SEWAGE DISPOSAL SYSTEM

MARYLAND STATE DEPARTMENT OF HEALTH

SUBDIVISION Wynfield ROAD 2781 Wynfield Road LOT 20, Section 3

PLOT PLAN
LOT 20

INDICATE NORTH. - NAME ADJOINING ROADWAY AS BASE LINE.

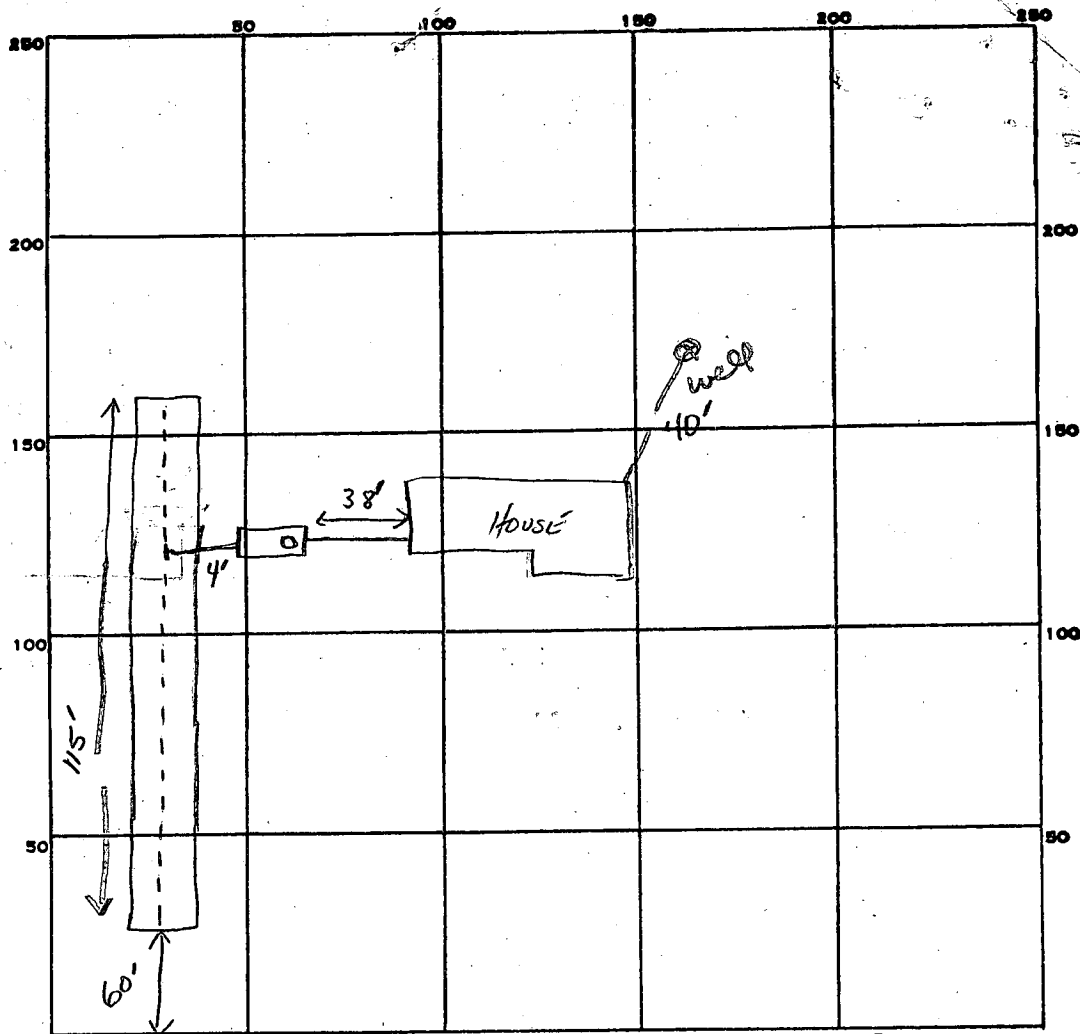
2-28-86 - Jack Fyock called - unable to hold sidewalls on deep trenches to put stone in; OK to in-

small leaching bed $\rightarrow$ 7' wide 114' long inlet 3.5' bottom 4.5', 1' stone below pipes.

REMARKS 2-27-86 CONTINUE TO DIG BED; OK TO ADD SOME; OK TO COVER ST TO HOUSE S. Abel

2-28-86 OK TO COVER ALL WORK. S. Abel

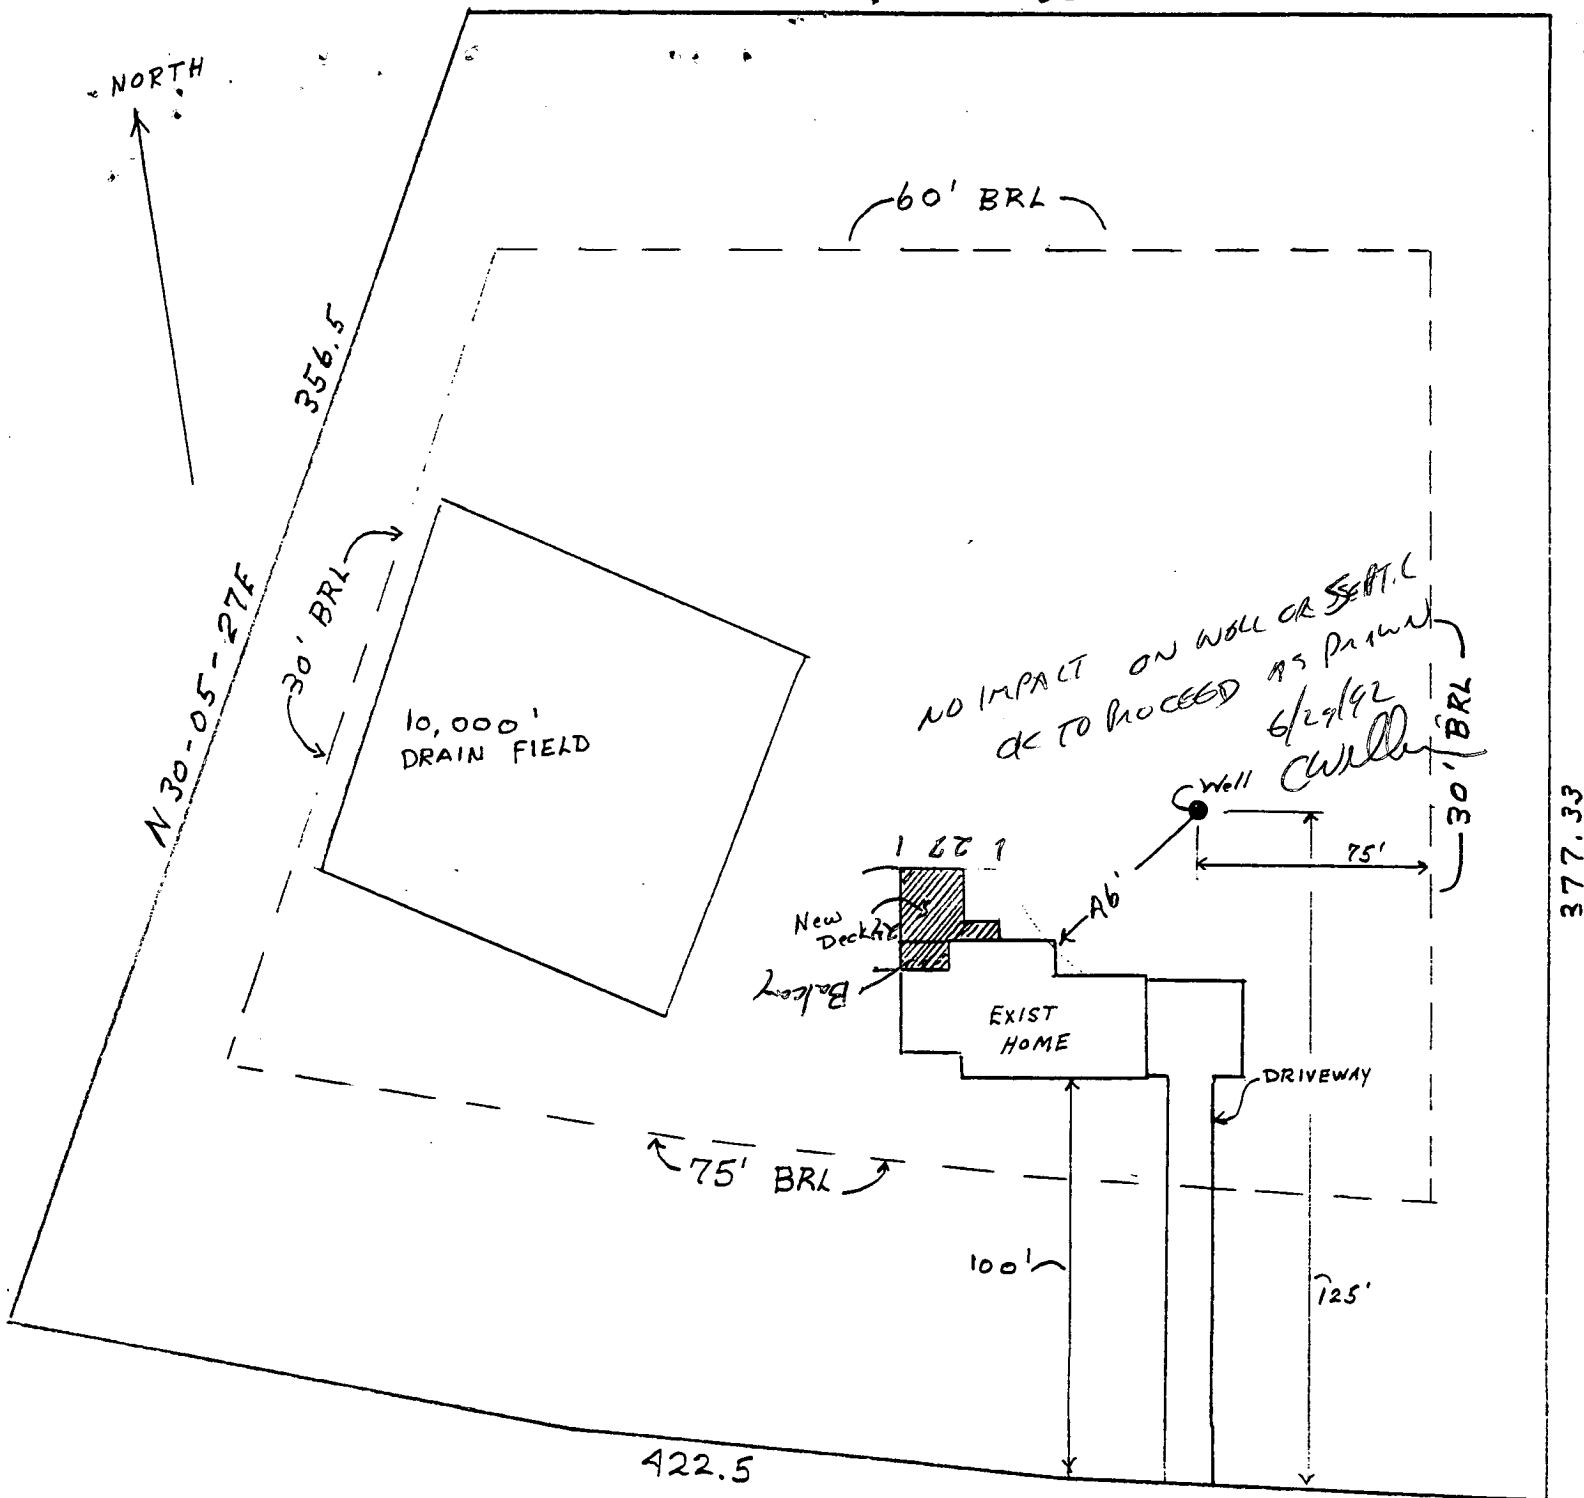
4 Bed room (500)
Home requires
130 linear feet of trench

Sketch OK as revised
for 4 Bed room home
for R. Shinn (300)

USE 2 TRENCHES 60" W.D. 10' APART 5' STARS BELOW INLET.
